OFFSITE DOSE CALCULATION MANUAL

Calvert Cliffs Nuclear Power Plant

CY-CA-170-301

Revision 2

Attachment 18
Map of Environmental Monitoring Sites for REMP (5 Km Radius)

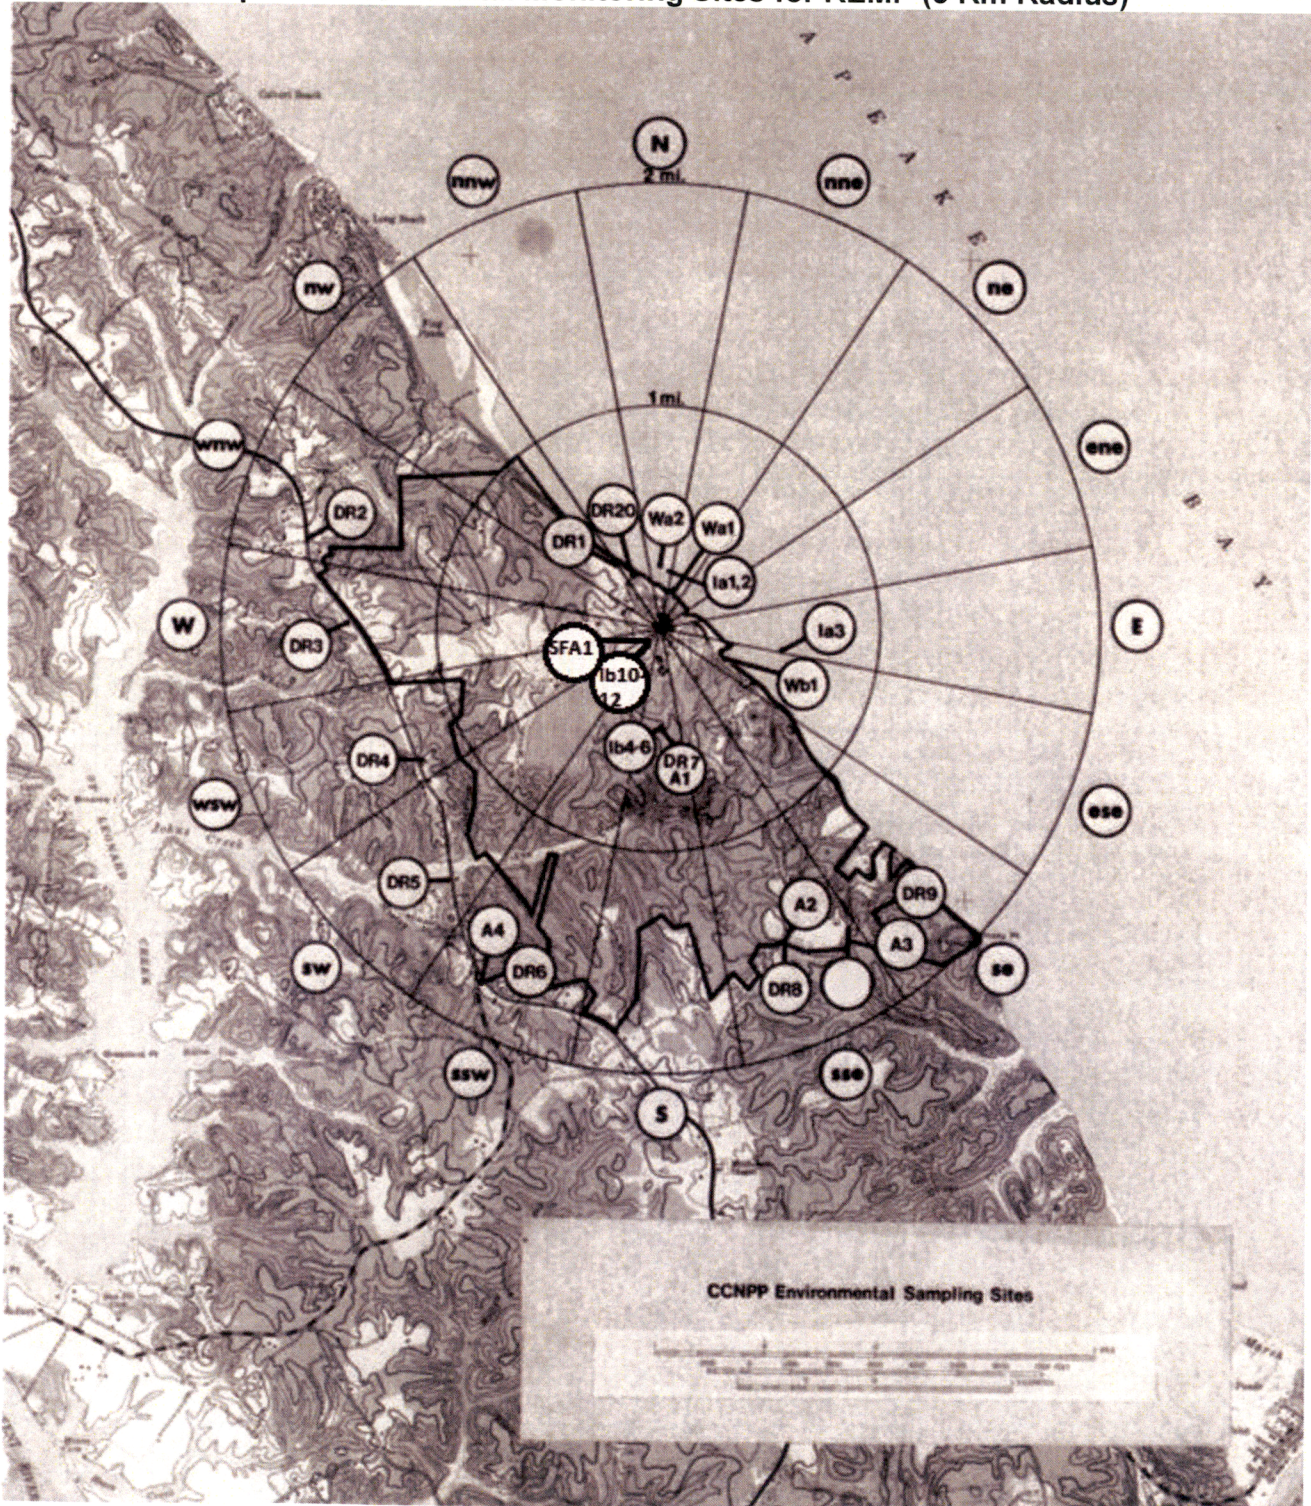
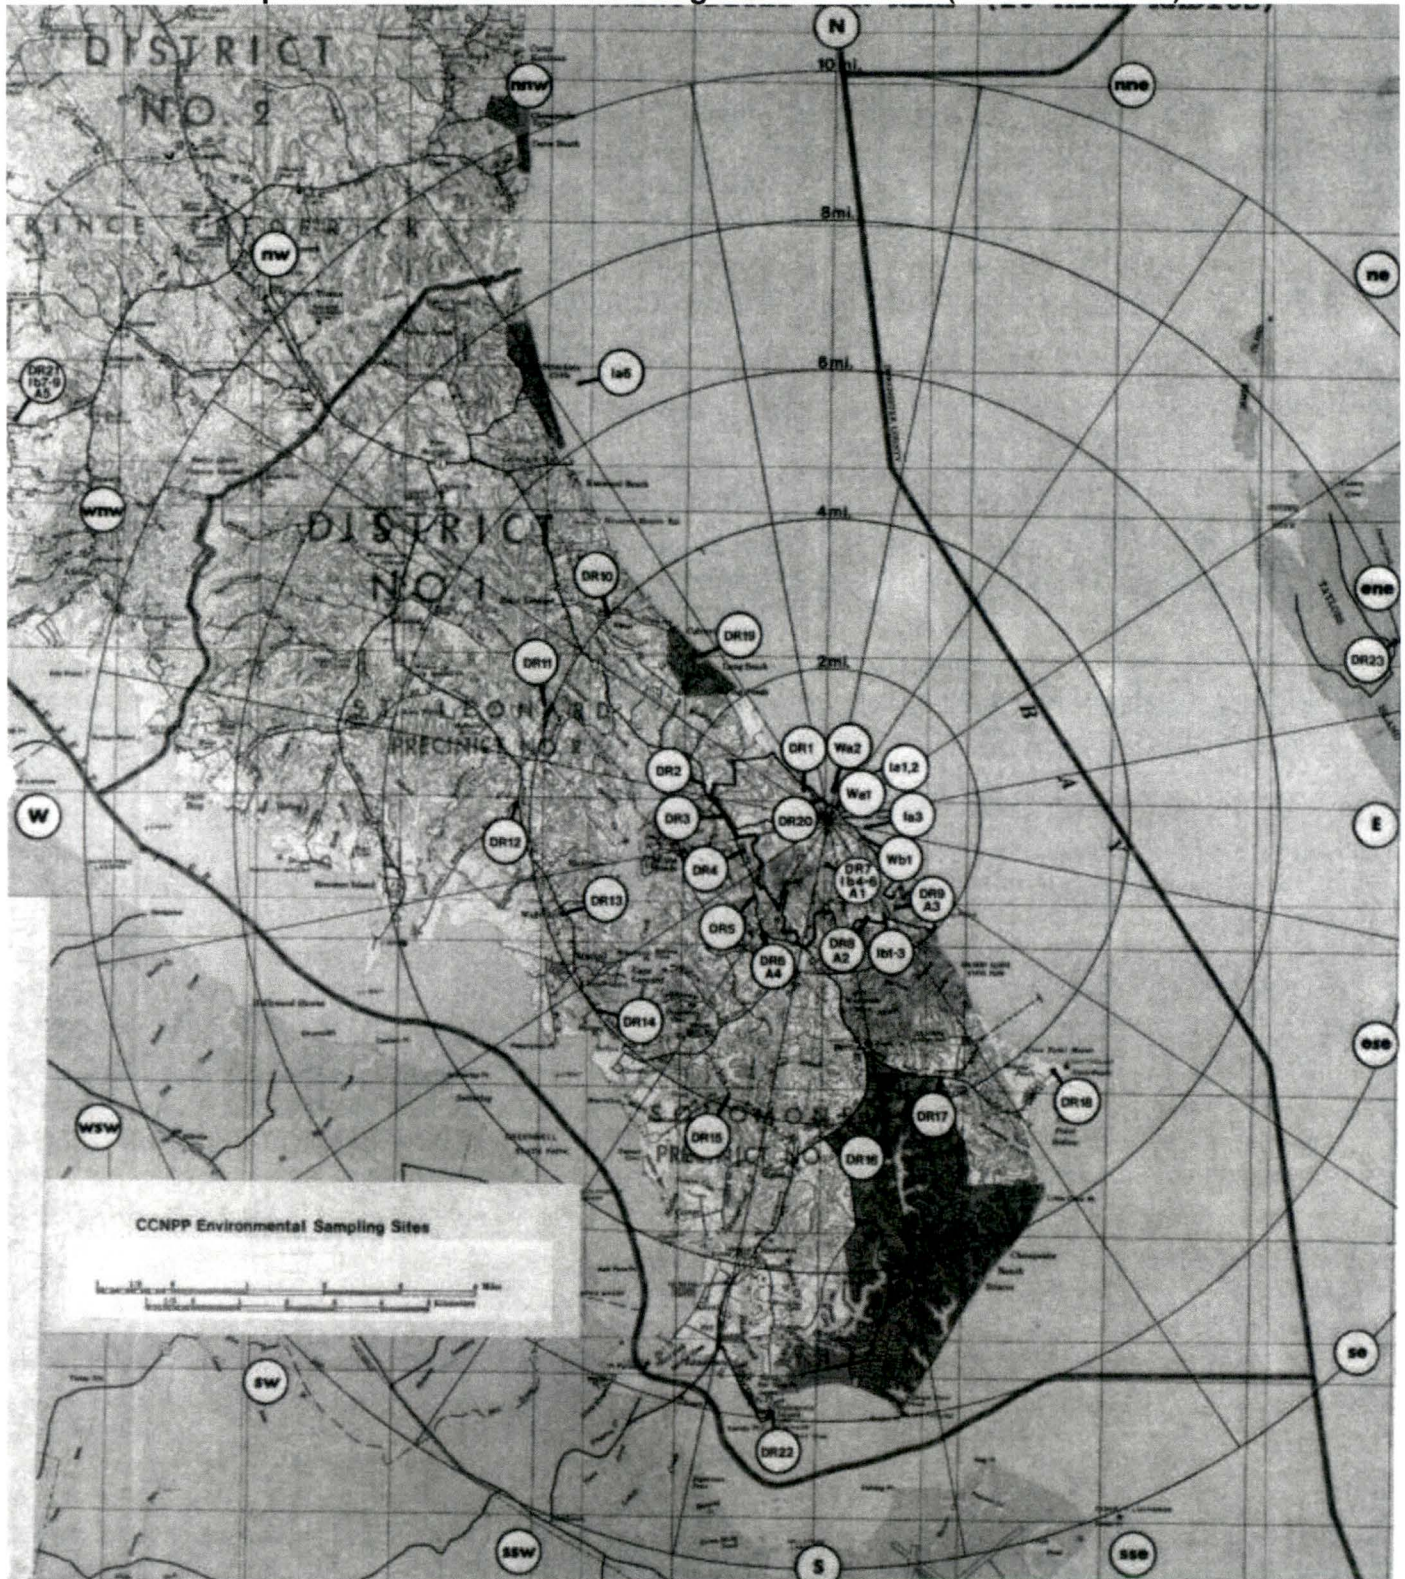
CHG	R1 PAGE	R2 PAGE	CHANGE TYPE	DESCRIPTION
8A	16	19	A	Added the following Performance References: 10. CY-AA-170-000, Radioactive Effluent and Environmental Monitoring Programs 11. CY-AA-170-300, Offsite Dose Calculation Manual Administration 12. CY-AA-170-3100, Offsite Dose Calculation Manual Revisions
9A	49	52	A	Changed the following with the underlined wording: "The code in parenthesis, for example, DR1, A1, defines generic sample locations in this control that can be used to identify the specific locations in the map(s) and table in the ODCM . Specific parameters of distance and direction sector from the central point between the two containment buildings and additional description where pertinent, is provided for each sample location in Table 3.12-1, and in a table and figure(s) in the ODCM ." To "The code in parenthesis, for example, DR1, A1, defines generic sample locations in this control that can be used to identify the specific locations in the map(s) and table in the ODCM . <u>Actual sample location designations can be found in Attachment 13.</u> Specific parameters of distance and direction sector from the central point between the two containment buildings and additional description where pertinent, is provided for each sample location in Table 3.12-1, and in a table and figure(s) in the ODCM (<u>see Attachments 13, 18 and 19</u>)."
